Re: *Construction Work Plan Addendum*
Bloody Brook, Onondaga County, New York
Voluntary Cleanup Agreement Index #D7-0001-01-09 (VCP Site No. V00501-7)

This letter and the enclosures to this letter are being submitted as an addendum to the March 2014 *Construction Work Plan* for the West Branch of Bloody Brook to address comments in New York State Department of Environmental Conservation's (NYSDEC's) April 23, 2014 letter. Below are the comments from the NYSDEC's April 23, 2014 letter and Lockheed Martin's response to the comments.

**2014 CONSTRUCTION WORK PLAN
WEST BRANCH OF BLOODY BROOK
ONONDAGA COUNTY, NEW YORK**

**TEMPORARY COFFERDAM (HEAD DAM) WITH
RIP-RAP APRON
ELEVATION**
(NOT TO SCALE)

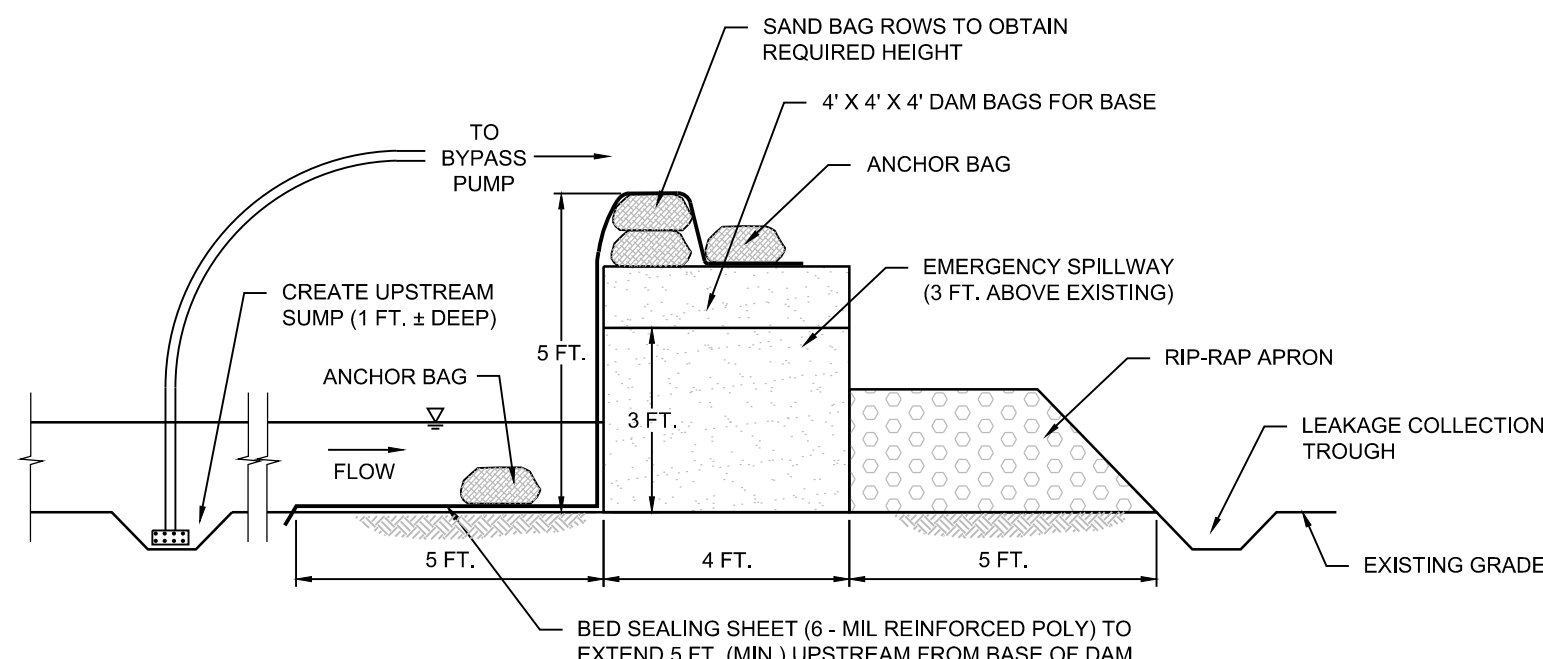
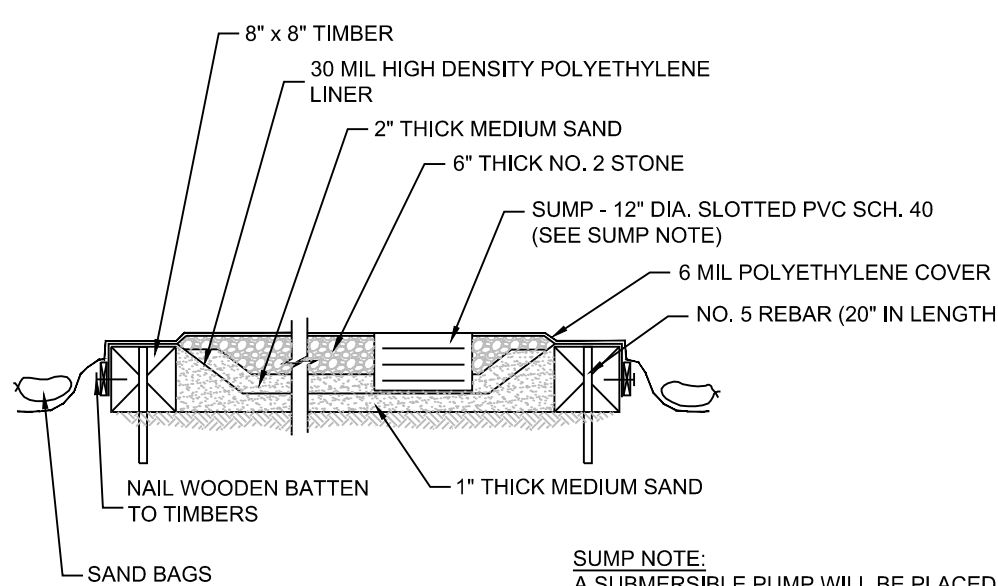
Section 2.3.5.4 Overtopping Contingency Measures. It is the Department's understanding that the most likely issue with overtopping of the dam is the backup of upstream water, which may potentially cause flooding upstream. Other issues such as the protection of personnel and equipment are discussed in Section 2.3.5.5 Mitigation Procedures. With respect to migration of contaminated sediment due to overtopping, this is limited through the actions discussed in the second bullet of Section 2.3.5.5 Mitigation Procedures (securing excavations at the end of each work day) and in the Response Action Matrix located in Section 2.3.5.6 Response Actions (i.e., "cover any open excavations with polyethylene sheeting and weight down with sandbags" during "water level within 2 feet of overtopping and rising"). Text should be added to include removal of head dam sandbags prior to an overtopping event to help alleviate the potential for upstream flooding.

When the water level threshold of "Water level within 2 feet of overtopping and rising" is met, the bypass pumps will be shut down and removed from the stream. The sandbags shown in the "Temporary Cofferdam (head Dam) with Rip-Rap Apron Elevation" detail found on Figure 16 will be removed to open the emergency spillway to allow consistent flow through the brook as needed."

STOCKPILE MANAGEMENT AREA
NOT TO SCALE

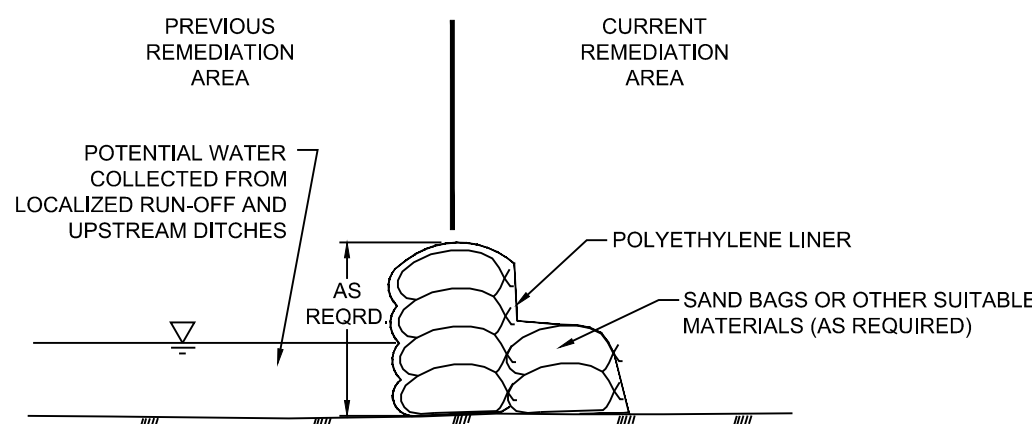
Figure 16, Stockpile Management Area – A sump should be added to the Stockpile Management Area detail.

Figure 16 has been edited to add a sump to the Stockpile Managements Area. The revised figure is enclosed with this letter.

LOCKHEED MARTIN CORPORATION
WETLAND TABLES AND
MISCELLANEOUS DETAILS

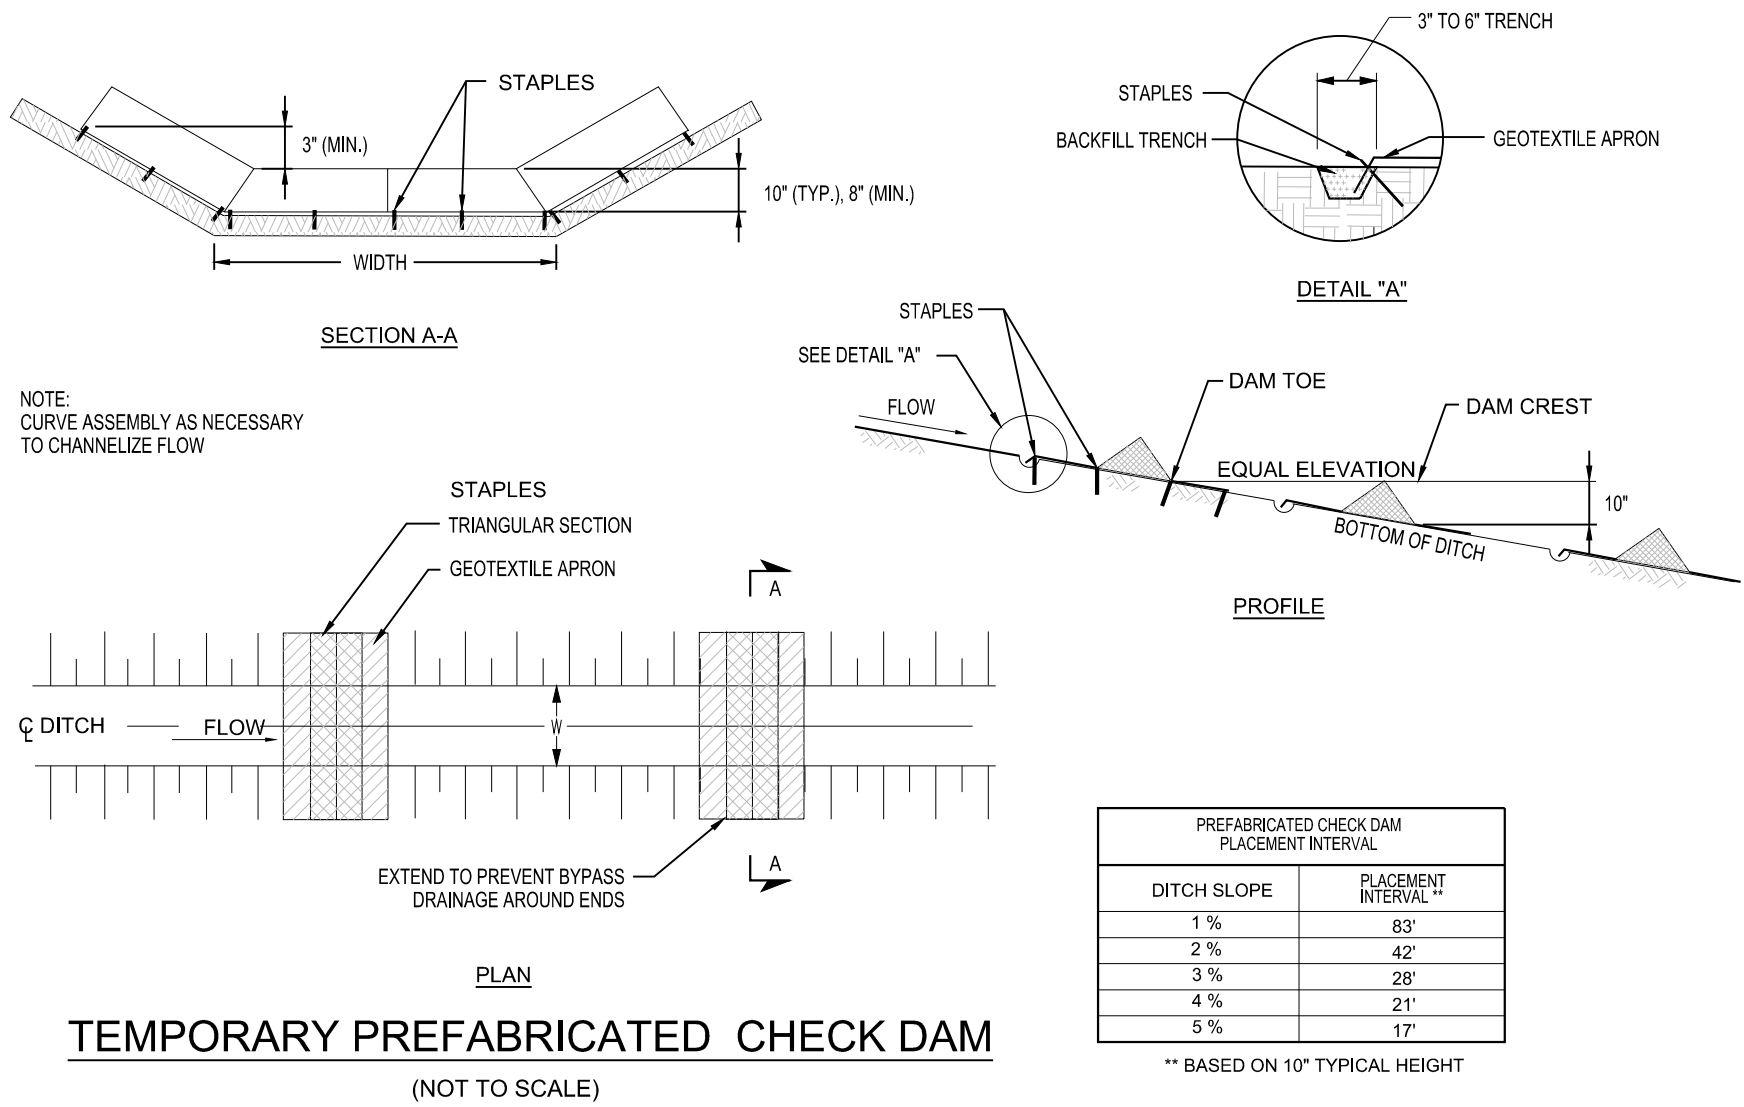
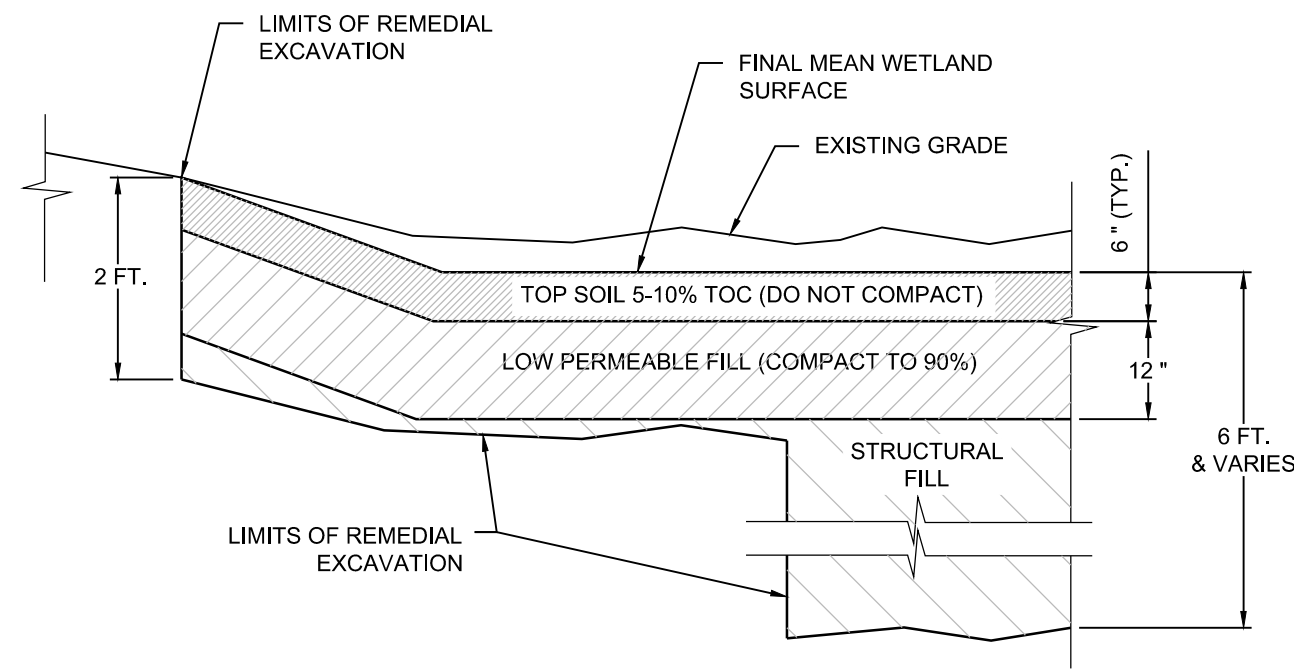
Figure 21 - Green Ash should not be used for replanting due to concerns regarding the spread of the Emerald Ash Borer. This tree species should be replaced with another New York State native tree.

Figures 21 and 22 have been edited to replace Green Ash with Black willow (*Salix niger*) and/or Sandbar willow (*Salix exigua*). The revised figures are enclosed with this letter.
